Access Compliance Report

Public Rights-of-Way

Intersection ID: N/A	Main Street: WAVERLY_WALK_AV	Cross Street: HONEYMEADE_CIR	Location: NW
ADA ID: 9E112EC455A2	Ramp Type: Directional1	Initial Pass/Fail: Pass	Overall Compliance: No
			Severity Score: 22.75

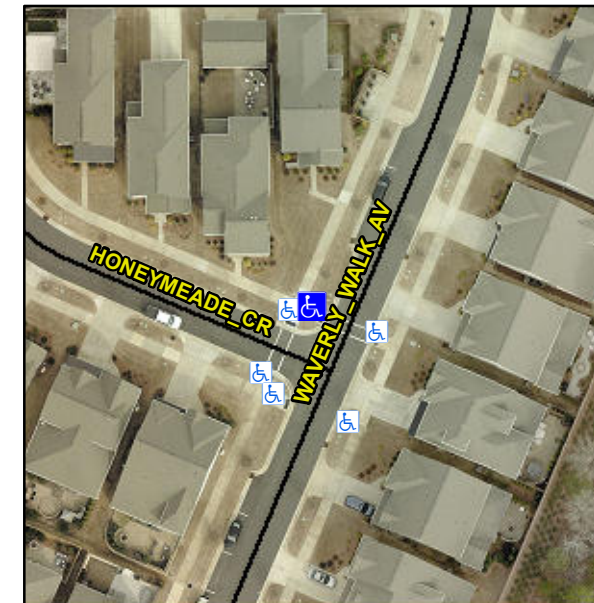
**R304.5.3, R304.2.2-Perp, R304.3.2-
Para, R304.5.2, R305.1.4, R305.2,
R302.7.2, R304.5.4**

Compliance	Description	Data	Compliance	Description	Data
N/A	Ramp Length (in)	143.0	No	Grade Break?	No
Yes	Ramp Width (in)	70.0	N/A	Grade Break Slope (%)	4.8
Yes	Ramp Slope (%)	7.1	N/A	Grade Break XSlope (%)	0.2
No	Ramp XSlope (%)	2.6			
Yes	Flare Type LT	N/A	Yes	Flare Type RT	N/A
N/A	Flare Slope LT (%)	N/A	N/A	Flare Slope RT (%)	N/A
N/A	Flare Traversable LT?	No	N/A	Flare Traversable RT?	No
Yes	Landing Length (in)	71.5	Yes	DWS Provided?	Yes
Yes	Landing Width (in)	70.0	Yes	DWS Contrast?	Yes
No	Landing Slope (%)	2.8	Yes	DWS Length (in)	24.0
No	Landing X Slope (%)	2.9	No	DWS Full Width?	No
N/A	Landing Curb? (Y/N)	N/A	No	DWS Offset LT (in)	5.0
N/A	Shared Landing?	Yes	Yes	DWS Offset RT (in)	12.0
Yes	Gutter Ponding?	No	No	Gutter Slope (%)	6.4
No	Gutter Lip Ht (in)	1.0	Yes	Gutter X Slope (%)	1.5
N/A	Painted X Walk1?	No		Road Slope (%)	2.5
	X Walk 1 Direction	To SE		Road X Slope (%)	0.8
	X Walk 1 Width (in)	N/A		Clear Space?	Yes

**Remove & Replace Entire Ramp.
Remove & Replace Gutter.**
